## Additional Information Response

Proposed Large-scale Residential Development (LRD) in St. Mochta's Lands, Kellystown LAP, Clonsilla, Co. Dublin

**Client Name:** Castlethorn Developments Luttrellstown Limited  
**Document Reference:** 15-038r.042 Additional Information Response  
**Project Number:** 15-038

This report forms part of a submission to Fingal County Council (FCC), in response to FCC's request for additional information for the proposed Large-scale Residential Development (LRD) on St. Mochta's lands within the Kellystown LAP in Clonsilla, Dublin 15. This report addresses the civil engineering items raised in FCC's additional information request.

**Figure 1 | Speed Reducing Measures Along Homezones**

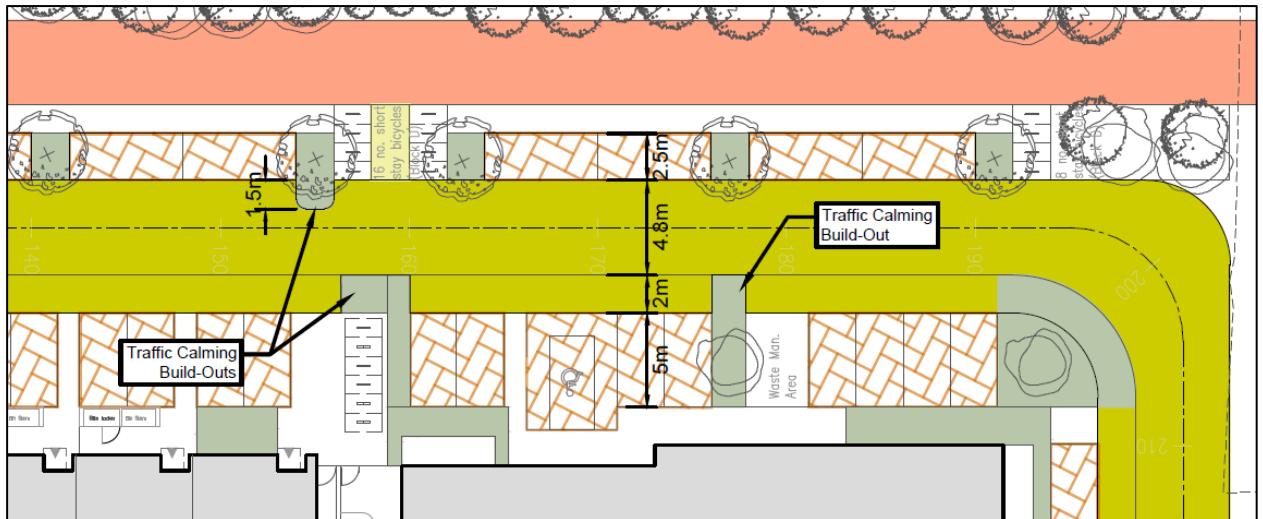
*Cross sections 5-5 and 4-4 are shared surface roads with tree pits and a service corridor but the total width of the road space hard surfacing is up to 7m in places. Further discussion is advised in relation to the shared surface areas.*

The current design has been coordinated to facilitate best practice in traffic calming, as outlined in DMURS. The shared surface roads have been designed with the following elements:

- A shared pedestrian and vehicular surface, with a carriageway width of 4.8m. This width is in accordance with Section 4.4.1 of DMURS.
- A 2m wide pedestrian refuge provided along the streets. Section 4.3.4 of DMURS suggests that shared surfaces should include verges that act as refuge zones, allowing pedestrians to step on and off the carriageway to let cars pass.

Section 4.4.8 of DMURS further notes that where a shared surface is proposed, designers may consider embedding a kerb line or drainage channel into the carriageway to indicate an area of pedestrian refuge. This is particularly important for visually impaired users who feel less comfortable on shared surfaces and also require a kerb line for navigation.

- Traffic calming measures: frequent buildouts and tree pits are included in the design to maintain low vehicular speeds. This requires vehicles to manoeuvre around buildouts, to yield to oncoming vehicles, and avoids straight alignments with uninterrupted sightlines. Note that where buildouts extend into trafficked areas, the tree pits remain outside the trafficked carriageway, in accordance with FCC's taking-in-charge requirements.

The following figure shows a typical example of the proposed road layout, indicating the carriageway width and highlighting the traffic calming measures incorporated along the street.

The proposed shared surface carriageway width and speed reducing measures were discussed with Niamh O'Connor from Fingal County Council's Transportation Section at the meeting held on the 21<sup>st</sup> of August, and FCC confirmed that the proposed homezone layout was considered acceptable in principle.
